Microcomputer Technical Information

QB-V850ESFX2 In-Circuit Emulator for V850ES/FE2, V850ES/FF2, V850ES/FG2, V850ES/FJ2, μ PD703229Y, μ PD70F3229Y Usage Restrictions		Document No.	ZBG-CD-05-0093	1/3
		Date issued	October 25, 2005	
		Issued by	Development Tool Group Multipurpose Microcomputer Systems Division 4th Systems Operations Unit NEC Electronics Corporation	
Related documents	QB-V850ESFX2 User's Manual: ZUD-CD-05-0129	Notification classification	<input checked="" type="checkbox"/> Usage restriction <input type="checkbox"/> Upgrade <input type="checkbox"/> Document modification <input type="checkbox"/> Other notification

Restrictions No. 17 and No. 18 have been added. See the attachment for details.

No. 5 Bug in accessing CnGNCTRL register during break (n = 0 to 3)

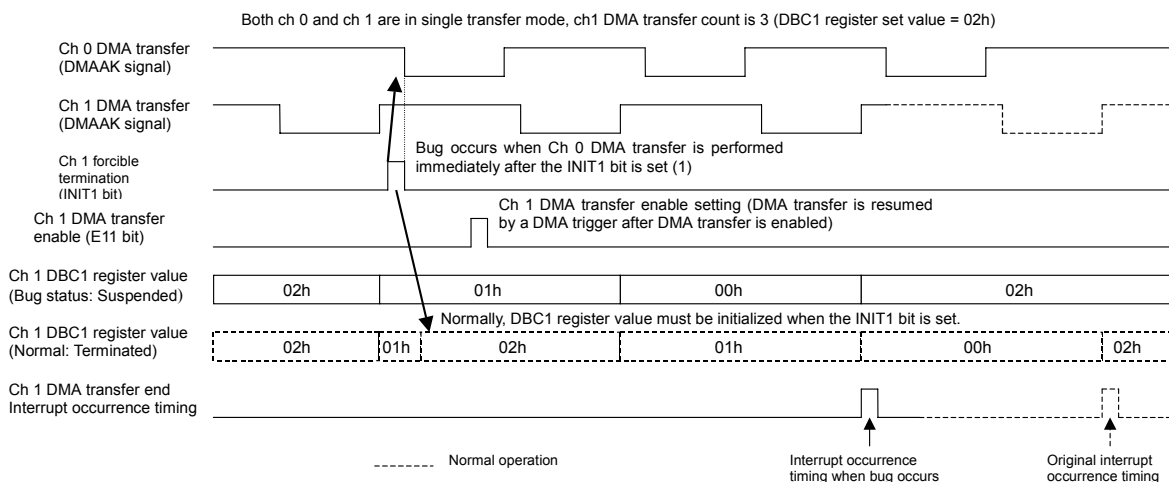
When a register access is performed in the following sequence, a forcible shutdown that should not take place normally may occur after the sequence is complete.

- (1) The EFSD bit of the CANn module control register (CnGMCTRL) is set.
- (2) The I/O register^{Note} is accessed.
- (3) The GOM bit of the CANn module control register (CnGMCTRL) is cleared.

- (a) If a break occurs immediately after the I/O register access in (2) occurs
- (b) If a break by the RAM monitor function or DMM function occurs immediately after the I/O register access in (2) occurs
- (c) Stepwise execution is performed for the I/O register access in (2)

Be sure to set the EFSD bit and clear the GOM bit successively when executing a forcible shutdown. Do not perform register access in the above sequence when not performing a forcible shutdown. Please regard this item as a permanent restriction.

No. 17 Illegal break occurs during program execution in internal RAM (2)

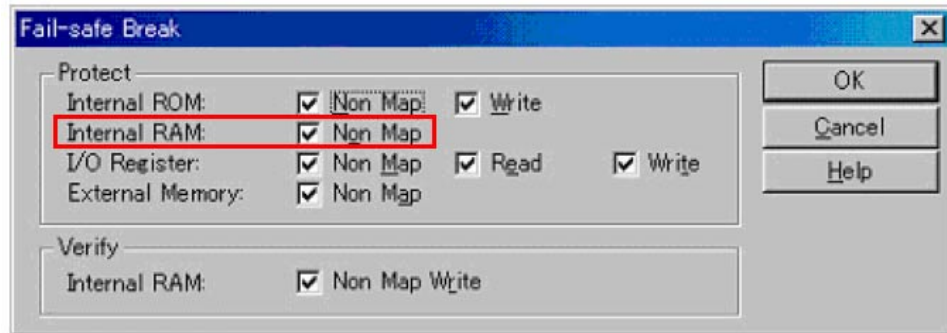
A non-map break occurs if all of the following conditions are satisfied, even if the program itself is correct.

- A program is executed in the internal RAM area.
- Data access for the internal RAM area is performed twice in succession.
- An execution branches to the internal ROM area using a JR or JARL instruction immediately after the above successive data access, or one NOP instruction after the above successive data access.

- Cancel the fail-safe break setting for the internal RAM in the debugger.

- Insert two or more NOP instructions between the successive data access for the internal RAM area and an instruction to branch to the internal ROM area.

Please regard this item as a permanent restriction.
